Three issues. A stronger coordinated model.

PROJECT RECORD / OCTOBER 2026

REVISED ELECTRICAL MODEL

Evidence set: Revit screenshots, October 3-10; Navisworks report v002(2), October 11. Issue 01 is a clash-review case. Issues 02 and 03 document Revit modeling and coordination troubleshooting.

01 / NAVISWORKS CLASH REVIEW

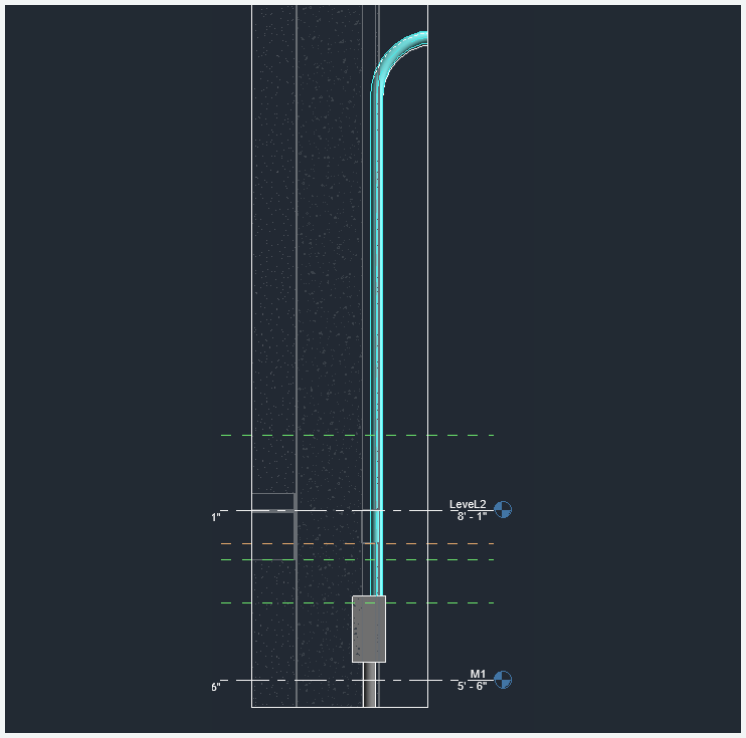
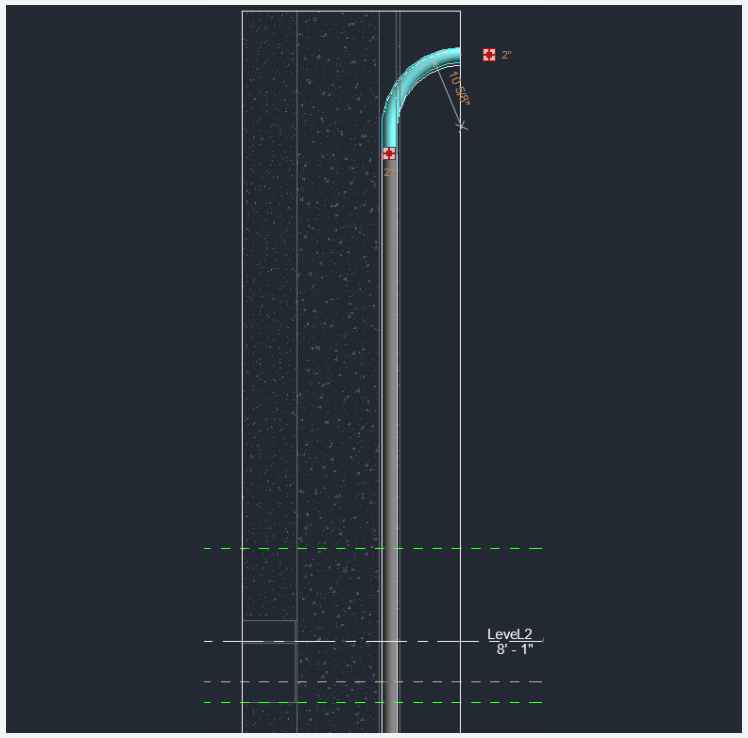
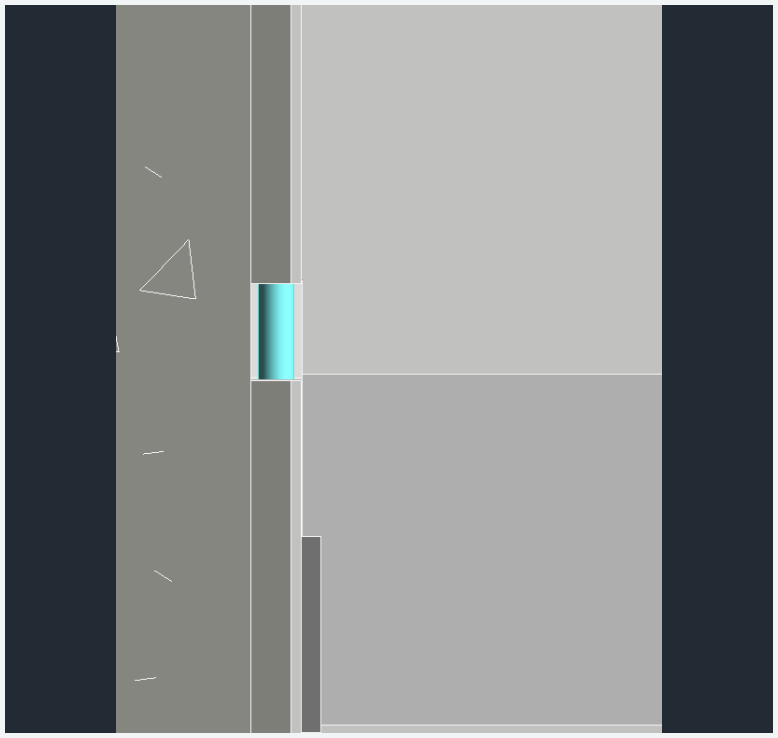
A partially embedded riser route was revised to make the concealed intent clear and remove the original elbow intersections.

Section shows the earlier relationship between the vertical run and wall face.

Revised section shows the concealed route and adjusted upper bend.

Cutaway retains the small exposed horizontal transition at the nook.

The risers and elbows intersected the architectural wall; the intended routing needed a clearer model representation.

Moved the risers fully into the wall and adjusted the elbow positions. Refreshed the model and reran the hard-clash tests.

Three original elbow pairs: Resolved. Remaining concealed-riser wall intersections: Approved as intentional for this educational review.

02 / REVIT EQUIPMENT & ROUTING TROUBLESHOOTING

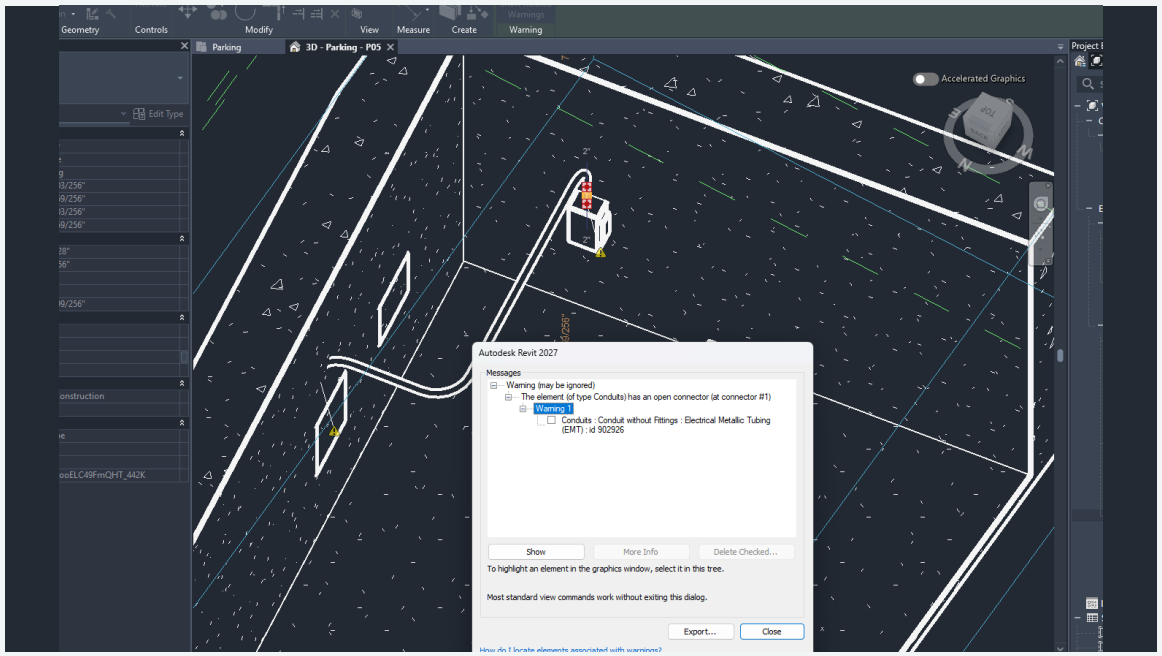
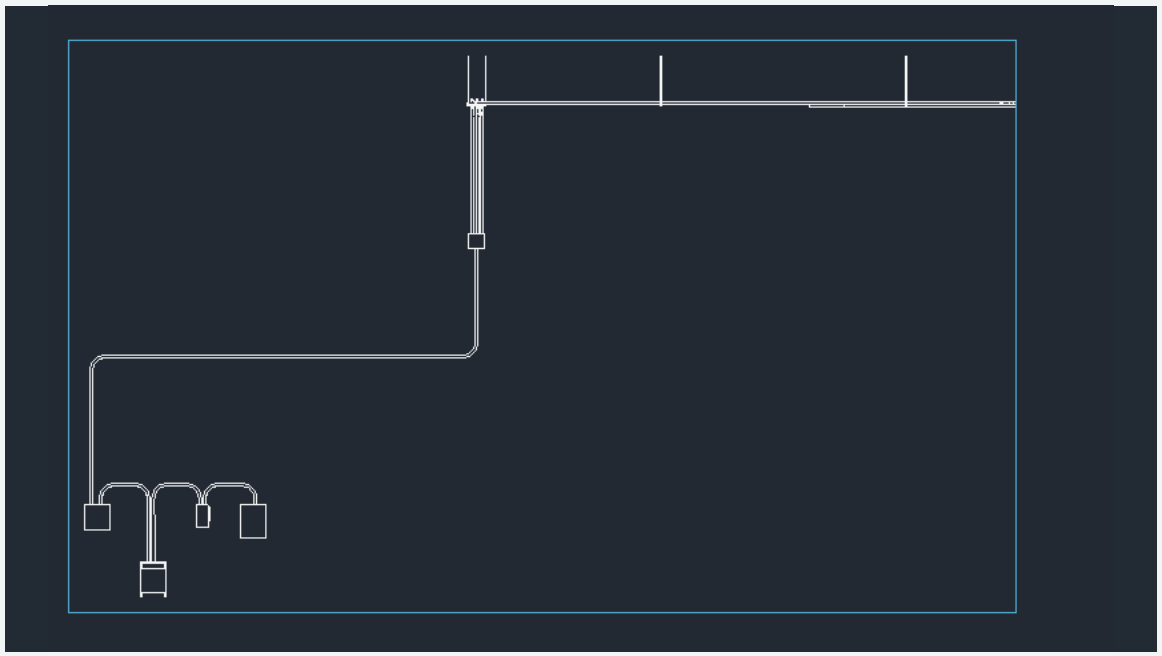
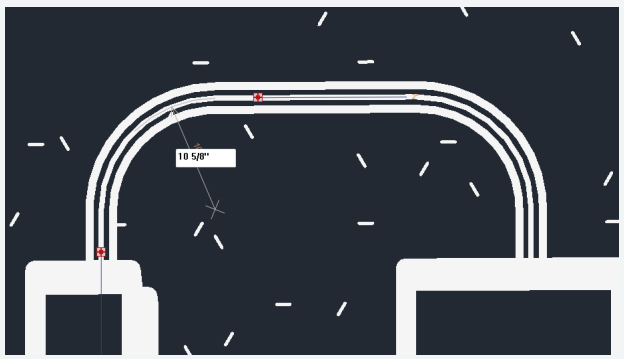
The earlier trial includes an open-connector warning and a difficult routing arrangement.

The bend study helped establish workable spacing and conduit transitions between enclosures. The displayed bend radius is 10 5/8 inches.

Reworked equipment spacing, mounting positions, and connector alignment. The revised model presents the panel, disconnect, and transformer connections as an organized system.

Modeled feed sequence: P480-1 > DS1 > TX1 > P208-1.

03 / REVIT JUNCTION-BOX CONNECTION

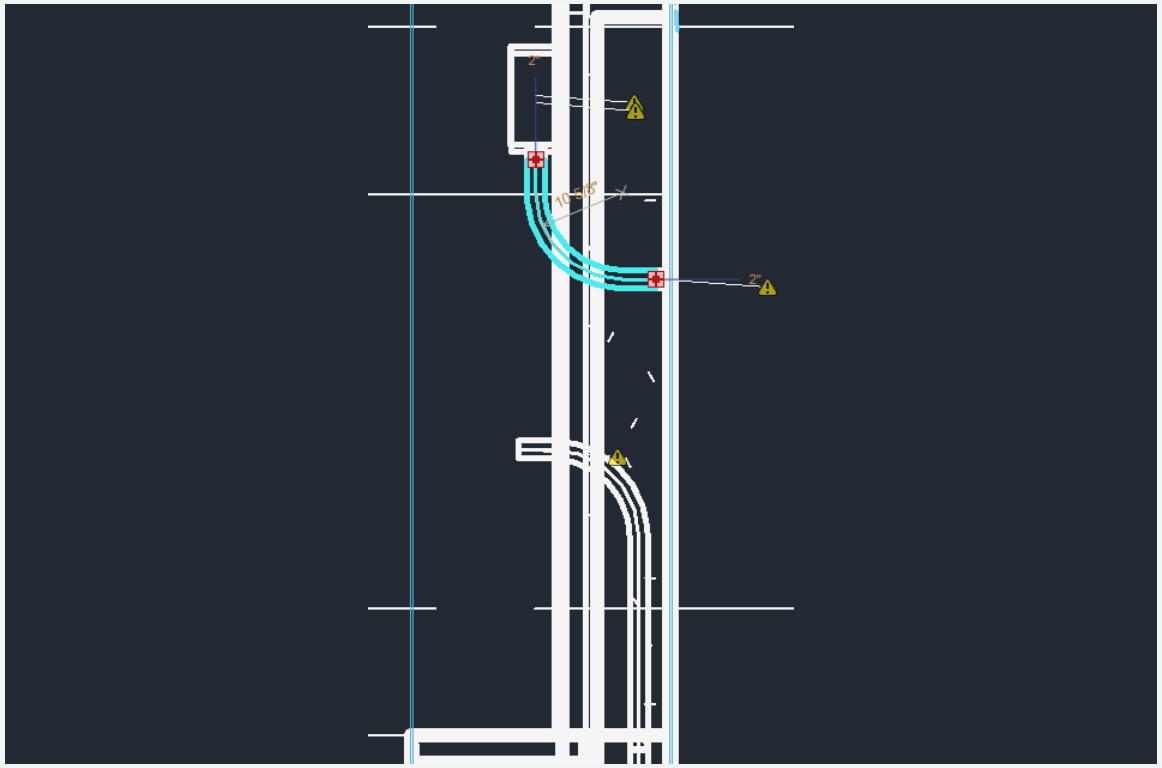
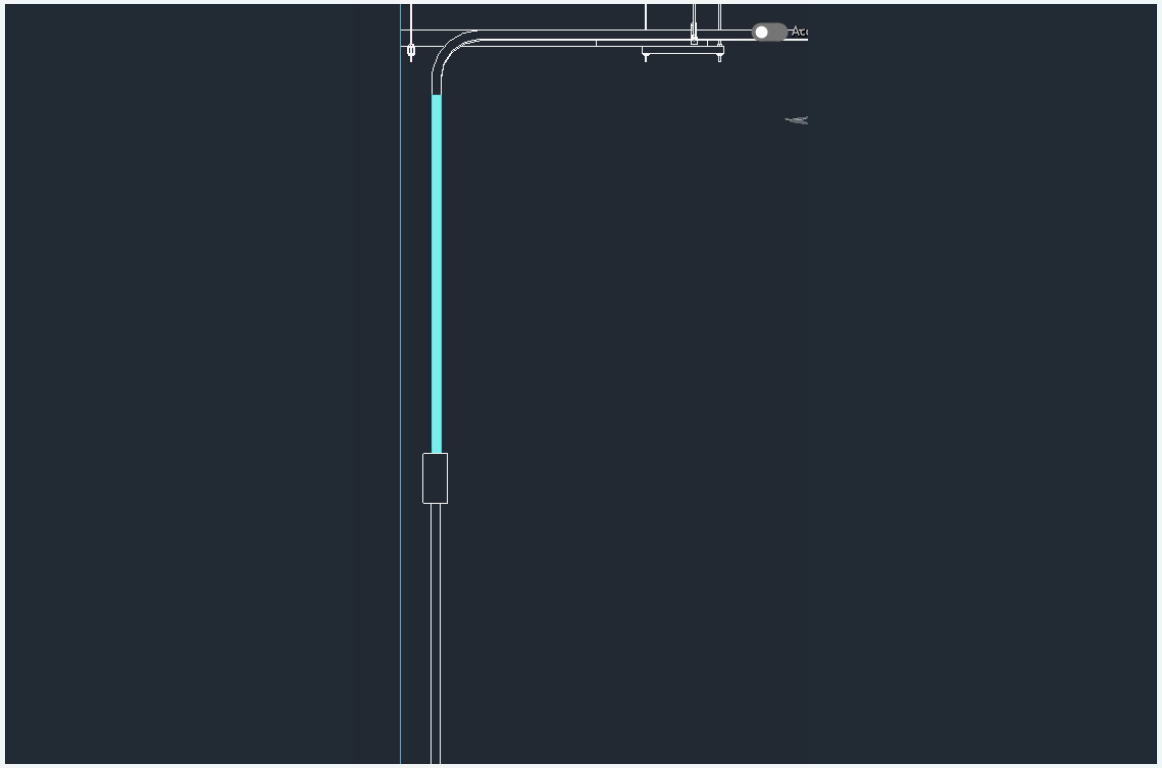
Earlier box and elbow configuration during connection troubleshooting.

Revised straight connection above J1, with the bend at the overhead transition.

The junction-box interface and elbow arrangement needed to fit the intended riser route and concealed wall placement.

Refined the J1 placement and conduit approach. Organized the top connection as a straight vertical run to the upper bend.

The final view records the revised connection geometry. The latest clash run has no New or Active results across all 13 tests.
